## MONTGOMERY COUNTY HISTORIC PRESERVATION COMMISSION STAFF REPORT

Address: 7400 Piney Branch Ave., Takoma Park Meeting Date: 4/25/18

Case Number: 37/03-18Z Staff: Dan Bruechert

**Proposal:** Siding and Window Replacement

FRONT ELEVATION

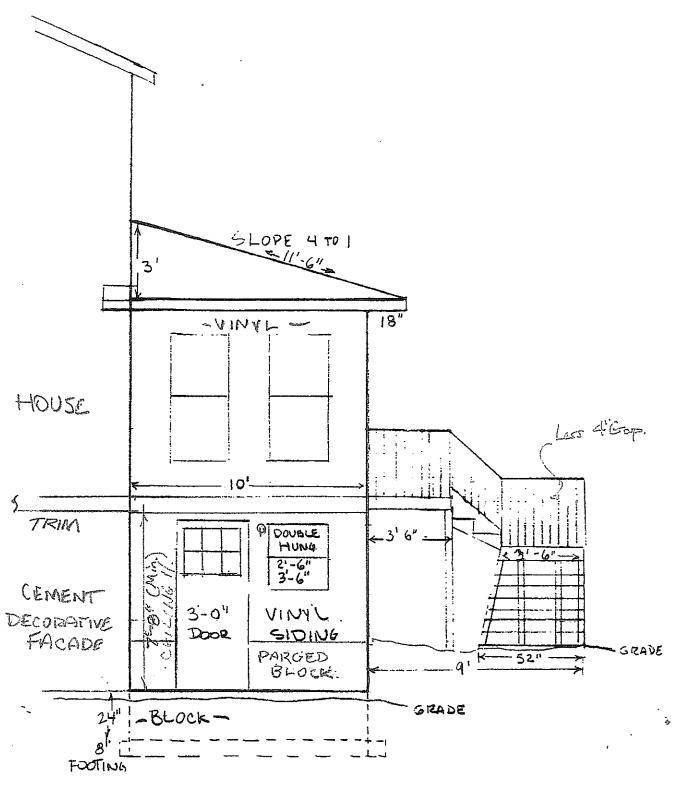
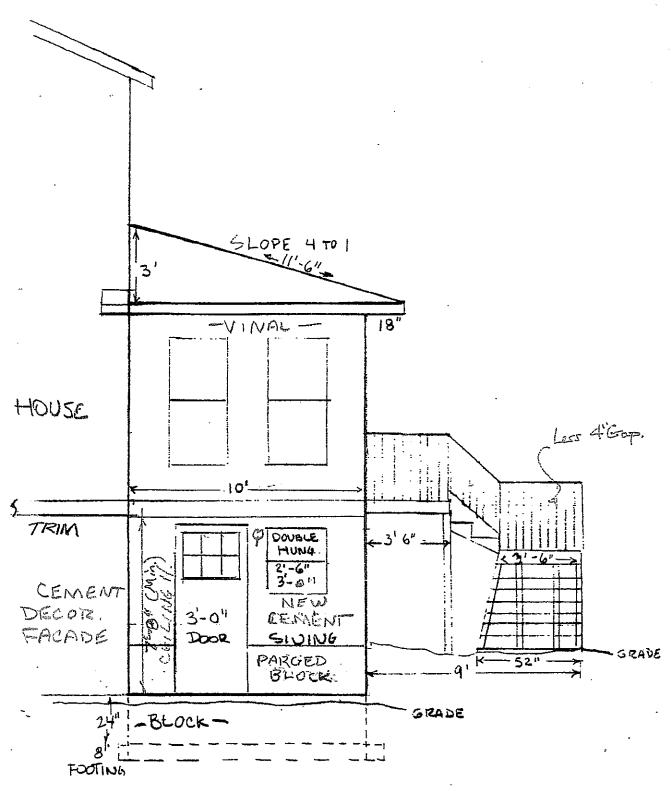
The applicant proposes to replace the vinyl siding on the basement level with cement shingles matching the materials and appearance found on the main massing of the house. Further, the applicant proposes to replace the five windows on the front elevation on the lower level with wood double-hung sash windows.

Removing the non-historic vinyl siding and replacing it with HardiPlank will result in a minor change in appearance to the house. The Hardi will be installed with the Cedarmill pattern that approximates the appearance of rough sawn wood with raised grain, is not typically approved by the HPC. The HPC typically requires Hardi siding to be installed with the smooth side facing out to better approximate the appearance of wood clapboards. Staff finds that in this instance the textured pattern is appropriate. Primarily, this is due to the fact that the Hardi is replacing and will be installed directly adjacent to vinyl siding that has a stamped pattern on it. This Hardi is being installed as a substitute material to vinyl, not wood clapboards.

The Hardi will not be an exact match for the vinyl as it is only 8mm (eight millimeters) thick and the vinyl creates a deeper shadow line. The proposed siding will not impact the scale and/or massing of the non-contributing resource and Staff supports its approval. The proposed wood sash windows in the lower level are appropriate in material and configuration. As these changes will not impact either the scale or massing of the non-contributing resource, these alterations should be approved as a matter of course.

Staff recommends that the Commission approve the HAWP application; and with the general condition applicable to all Historic Area Work Permits that the applicant will present <u>3 permit sets</u> of drawings to HPC staff for review and stamping prior to submission for permits (if applicable). After issuance of the Montgomery County Department of Permitting Services (DPS) permit, the applicant will arrange for a field inspection by calling the DPS Field Services Office at 240-777-6370 prior to commencement of work <u>and</u> not more than two weeks following completion of work.
